UNITED STATES PATENT AND TRADEMARK OFFICE

APPLICATION NO.	FILING DATE	FIRST NAMED INVENTOR	ATTORNEY DOCKET NO.	CONFIRMATION NO.
10/777,974	02/12/2004	Pete Balsells	3007	7432

Office Action Summary

DETAILED ACTION

Balsells, 5,411,348

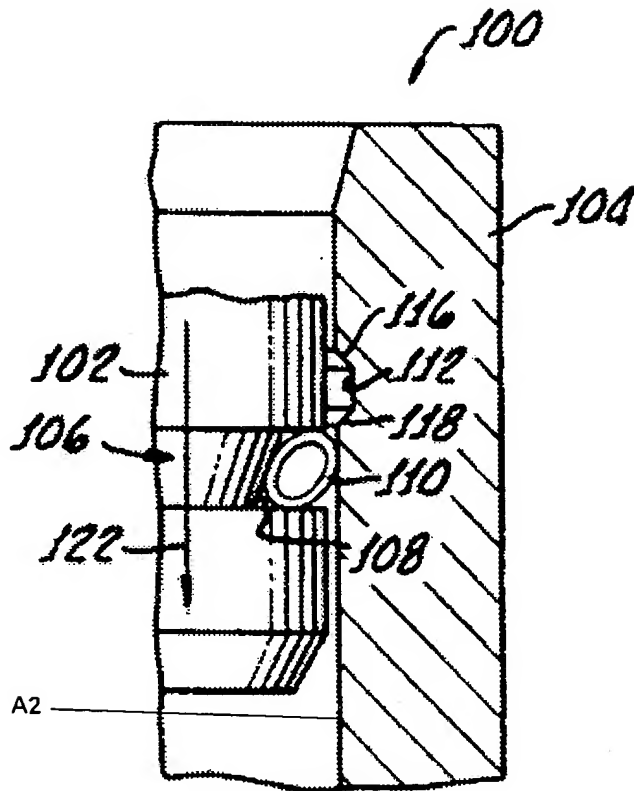
Claims 1-7 and 10-15 are rejected under 35 U.S.C. 102(b) as being anticipated by Balsells, 5,411,348 (see marked-up attachment).

Regarding claim 1, Balsells discloses, in Figure 7c, Balsells discloses a spring holding connector comprising a housing **104**, a shaft **102**, and a circular spring **110**.

The housing **104** has a bore **A2** therethrough. The shaft **102** is rotatably and slidably received in the bore **A2**. The shaft **102** has a circular groove **106**. The spring **110** is disposed in the groove **106**. The groove **106** is sized and shaped.

Regarding claim 7, the groove **106** includes an uneven bottom. Applicant should note that the tapered bottom is uneven relative to the groove.

Regarding claim 13, the groove **106** has a tapered bottom **108**.
